**ERRORS AND OMISSIONS**

**EASTERN WIND INTEGRATION TRANSMISSION STUDY (“EWITS”)**

**Danny Dees**

**April 4<sup>th</sup>, 2011**

**The Effect of Correcting EWITS Figure 3**

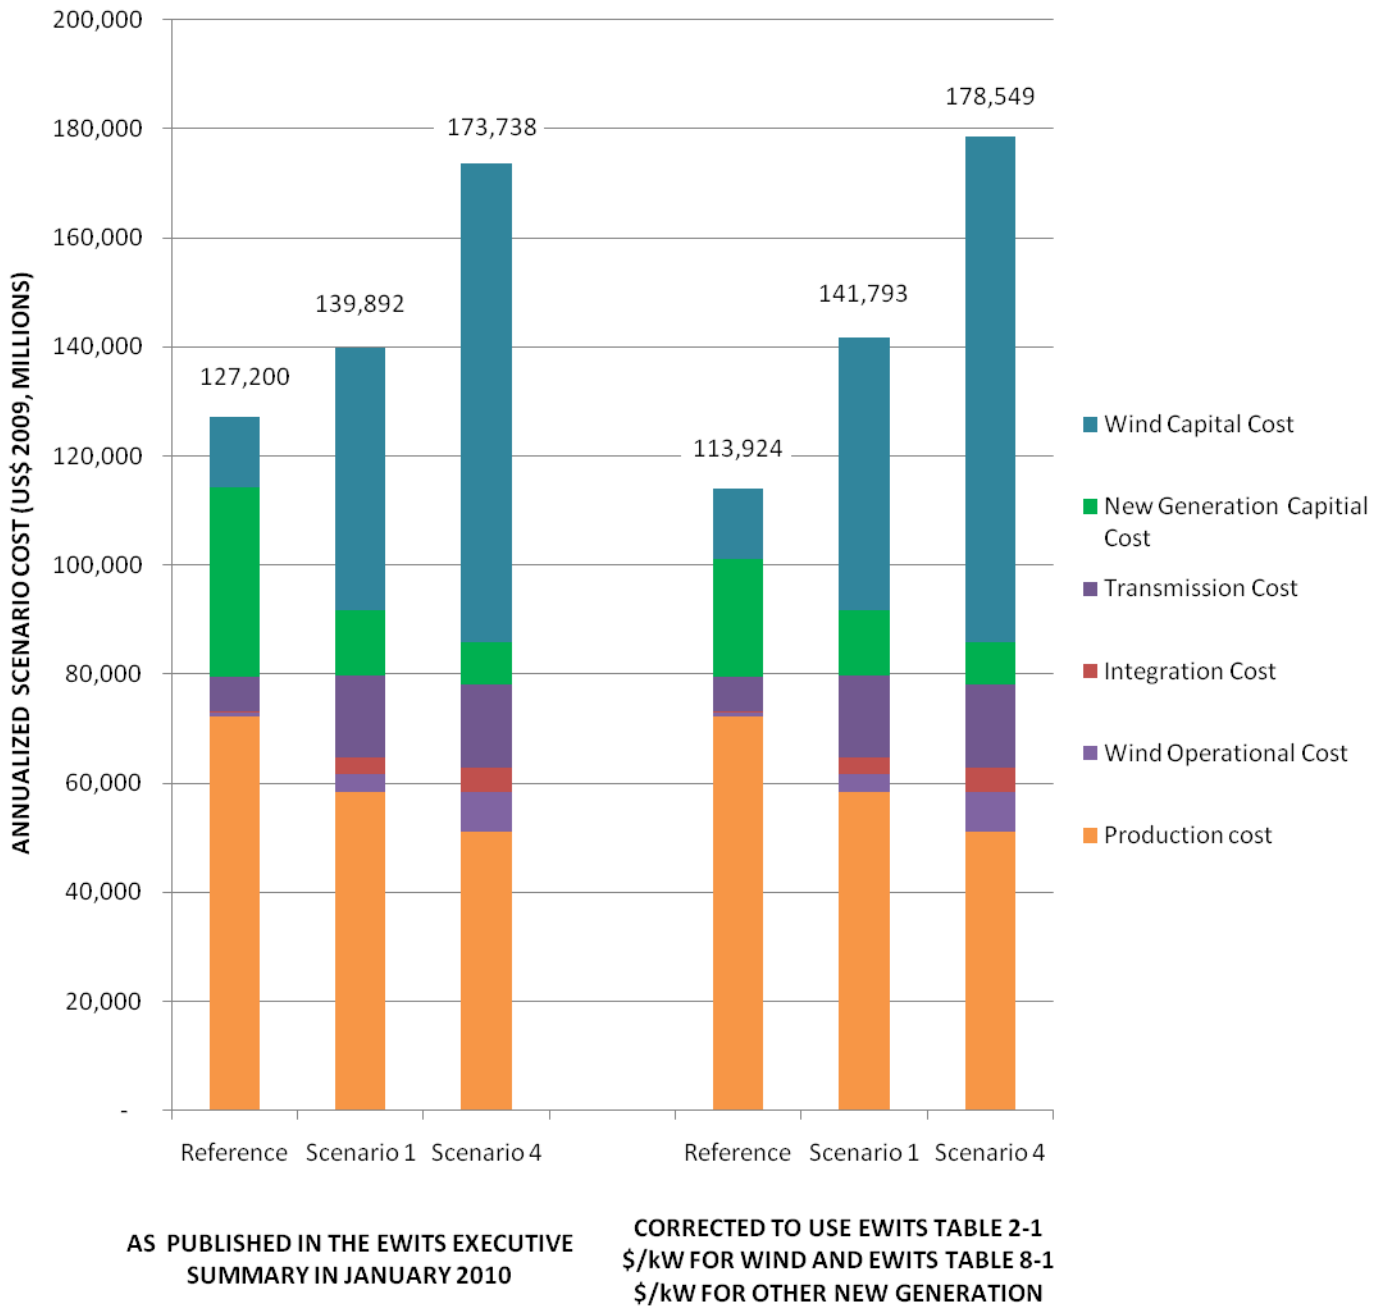
It was obvious that the New Generation Capital Costs in Figure 3 of the EWITS Executive Summary (p. 30) in the January 2010 release of the EWITS report were not consistent with the assumptions published in EWITS Table 8-1 (p. 209).

The Figure 3 error was noted and reported to NREL more than a year before it was acknowledged in EnerNex's February 13<sup>th</sup>, 2011 response to a draft of this critique. Thanks are extended to the staff of EnerNex for revising the EWITS report to include a corrected Figure 3 and arranging to have the revised report posted in February 2011.<sup>19</sup> Also, the Wind Capital Costs presented in the EWITS Figure 3 were found to be inconsistent with the \$/kW values published in EWITS Table 2-1 (p. 67).<sup>20</sup>

The following figure compares the EWITS Figure 3 annual costs for the Reference Case, wind Scenario 1 (the least costly 20% wind energy scenario studied for the EWITS) and wind Scenario 4 (the 30% wind energy scenario) AS PUBLISHED January 2010 to the correct values. Appendix C provides the detailed calculations that support the following figure.

- The *incorrect* January 2010 version of EWITS Figure 3 indicates that the annualized cost for the 20% wind Scenario 1 is approximately \$13 billion per year more costly (i.e., approximately 10%) than the Reference Case. After the correction, the cost for wind Scenario 1 is shown to be approximately \$28 billion per year more costly (i.e., approximately 24%) than the Reference Case. (Also, if the effects of post-bubble natural gas prices and the excluded grid overlay costs were included in these cost, this cost difference would be even greater.)
